OMNI OFFICE PARK SUBDIVISION

APPLICATION NUMBER 3 DATE December 21, 2006

OMNI OFFICE PARK SUBDIVISION, SIXTH ADDITION, RESUBDIVISION OF LOT 2

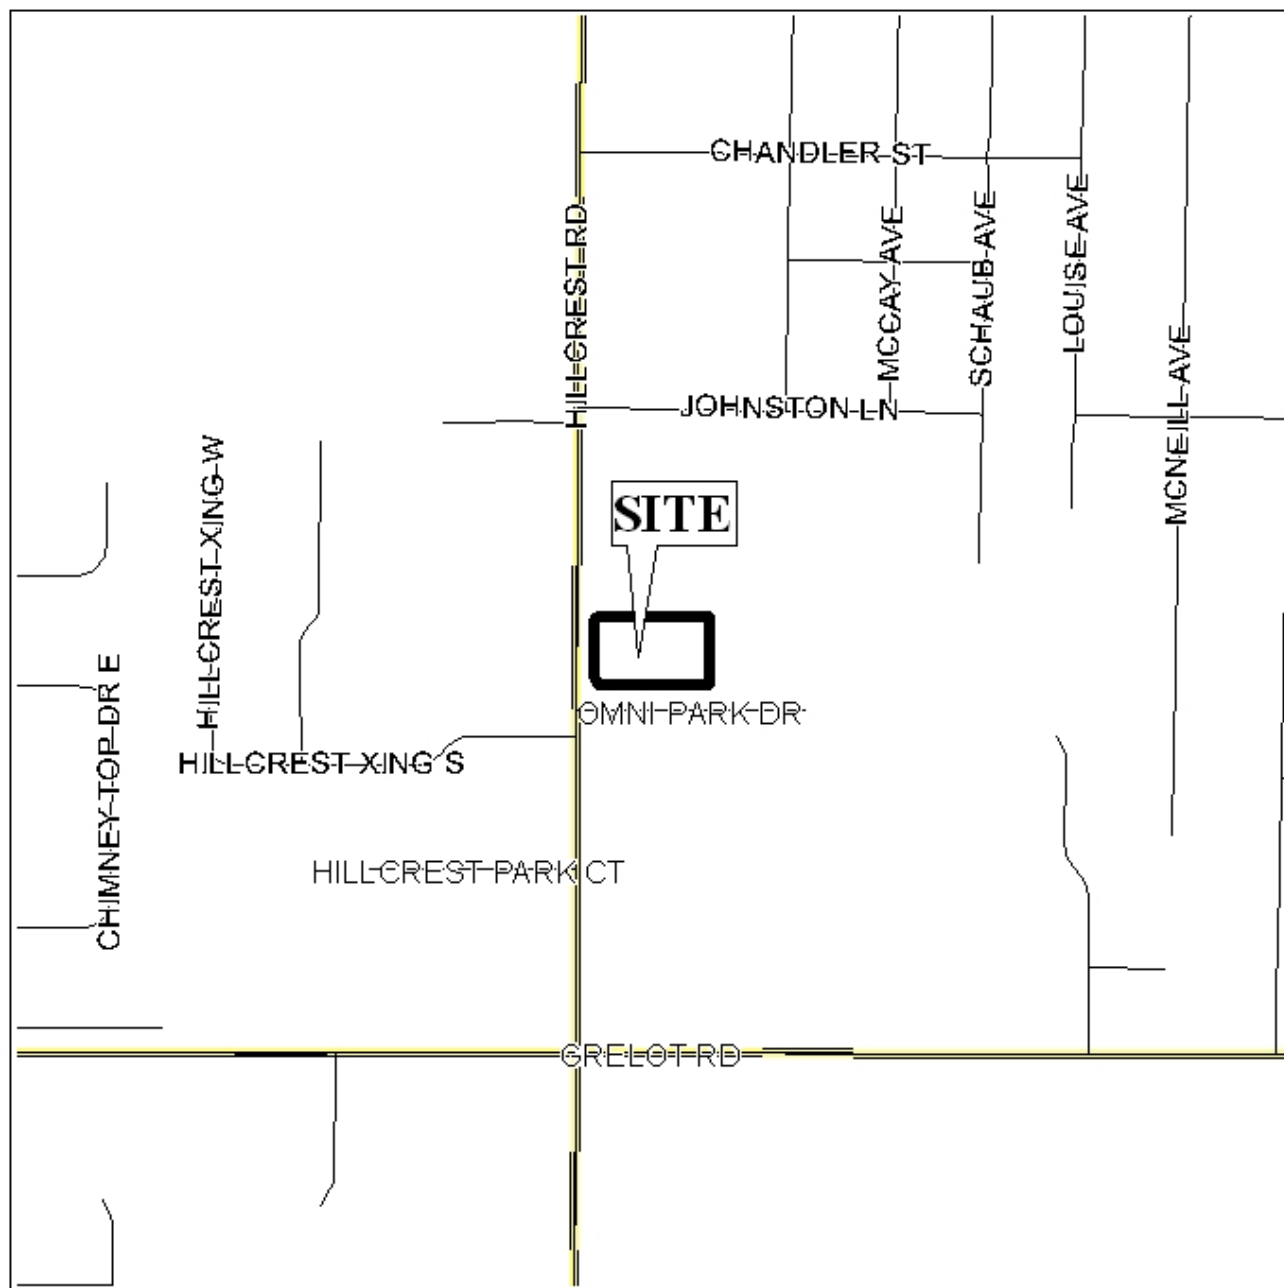
Engineering Comments: Show drainage easement. For development to tie to existing detention pond, confirm the detention pond was intended to accept storm water from these lots. Verify that the detention pond has the capacity and functionality to accept the storm water from the lots. Must comply with all storm water and flood control ordinances. Any work performed in the right of way will require a right of way permit.

Traffic Engineering Comments: Driveway numbers, size, location and design to be approved by Traffic Engineering and conform to AASHTO standards.

Urban Forestry Comments: Property to be developed in compliance with state and local laws that pertain to tree preservation and protection on both city and private properties (State Act 61-929 and City Code Chapters 57 and 64).

Fire Department Comments: All commercial projects shall comply with the 2003 International Fire Code and Appendices B through G as adopted by the City Of Mobile on July 6, 2004. All One- or Two-Family residential developments shall comply with Appendices B, C and D of the 2003 International Fire Code as adopted by the City of Mobile on July 6, 2004.

The site is located on Hillcrest Road, a major street with 100' of right-of-way, in compliance with the Major Street Plan component of the Comprehensive Plan. As Hillcrest Road is a major street, access management is a concern. Given the existing development along Hillcrest Road, limiting the site to access Omni Park Drive would be appropriate.

The plat meets the minimum requirements of the Subdivision Regulations and is recommended for Tentative Approval, subject to the following conditions: 1) placement of a note on the final plat stating that Lot 2B is denied access to Hillcrest Road; 2) placement of a note on the final plat stating that curb cut number, size, location and design to be approved by Traffic Engineering; 3) provision of a buffer in accordance with section V.A.7 where the site abuts residentially zoned property; and 4) compliance with Engineering Comments (Show drainage easement. For development to tie to existing detention pond, confirm the detention pond was intended to accept storm water from these lots. Verify that the detention pond has the capacity and functionality to accept the storm water from the lots. Must comply with all storm water and flood control ordinances. Any work performed in the right of way will require a right of way permit).
